Staff Summary Report

Development Review Commission Date: **04/22/08**

SUBJECT: Hold a public meeting for a Development Plan Review for CARSTEN INSTITUTE EXPANSION located at 3345 South Rural Road.

DOCUMENT NAME: DRCr_CarstenInstitute_042208**PLANNED DEVELOPMENT (0406)**

PROPOSED SITE PLAN
SCALE: 1" = 20'-0"

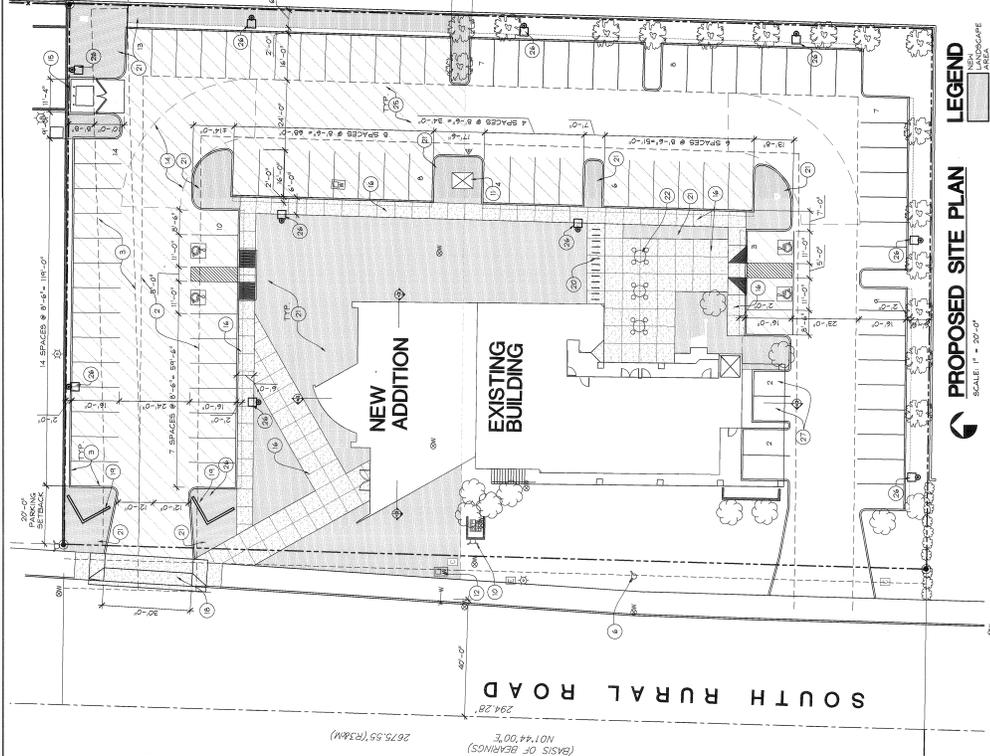
1. Provide upgraded paving at each driveway apron consisting of unit paving. Extend unit paving in the driveway from the back of the accessible public sidewalk bypass to 20'-0" on site and from curb to curb at the drive edges.
2. Utility equipment boxes for this development shall be finished in a neutral color (subject to utility provider approval) that compliments the coloring of the buildings.
3. Accessible Parking spaces shall be relocated to a location that is closest to the sidewalk leading to building entrance.
4. Place exterior, freestanding reduced pressure and double check backflow assemblies in pre-manufactured, pre-finished, lockable cages (one assembly per cage). If backflow prevention or similar device is for a 3" or greater water line, delete cage and provide a masonry or concrete screen wall following the requirements of Standard Detail T-214.

17. The landscape plan does not provide the required street trees. Update the plan to show one tree for every thirty 30'-0" of frontage, a total of nine trees will be required along the Rural Road street frontage.

- The landscape plan does not provide the required street trees. Update the plan to show one tree for every thirty 30'-0" of frontage, a total of nine trees will be required along the Rural Road street frontage.

- The landscape plan does not provide the required trees in the new and existing landscape islands. Each landscape island requires one (1) tree and five (5) ground covers/shrubs.

BUILDING
ELEVATIONS

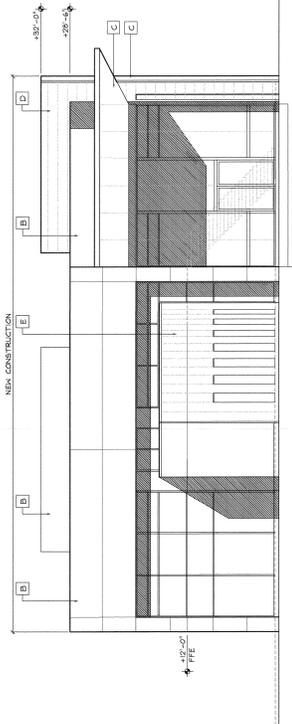
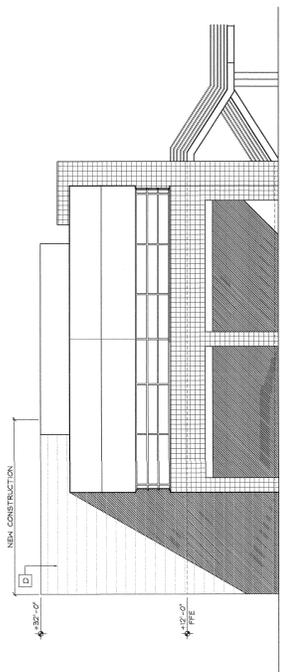
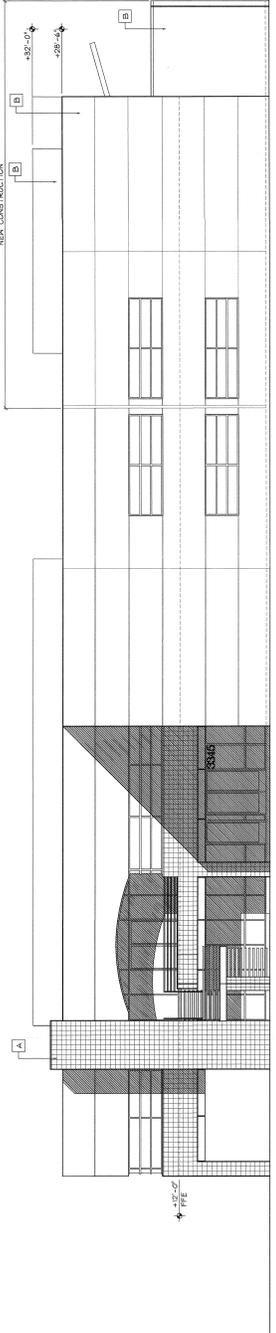
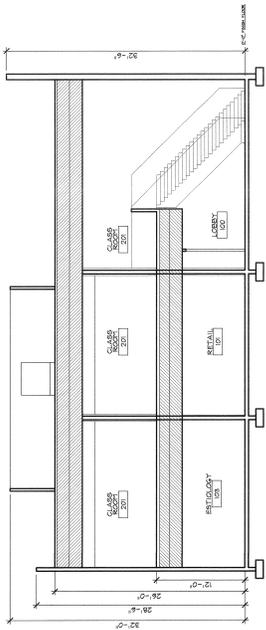
6. The materials and colors presented are approved as presented:
Primary building – E.F.I.S. painted: Off white and CMU
Accent bands for Ground Floor Bookstore –E.F.I.S. – *Terra cotta*
Vertical Accent – Ceramic Tile – Lavagna Nero
Specific colors and materials exhibited on sample board are approved by planning staff. Submit any additions or modifications for review during building plan check process. Planning inspection staff verifies colors and materials during the construction phase.

7. Provide secure roof access from the interior of the building. Do not expose roof access to public view.
8. Conceal roof drainage system within an architectural feature of the building. Minimize visible, external features, such as overflows, and where needed. Incorporate these into the design of the building elevations.

9. Incorporate lighting, address signs, incidental equipment attachments (alarm klaxons, security cameras, etc.) where exposed into the design of the building elevations.

10. Locate the electrical service entrance section (S.E.S.) inside the building or inside a secure yard, concealed from public view.
11. Exposed conduit, piping, etc. is not allowed.
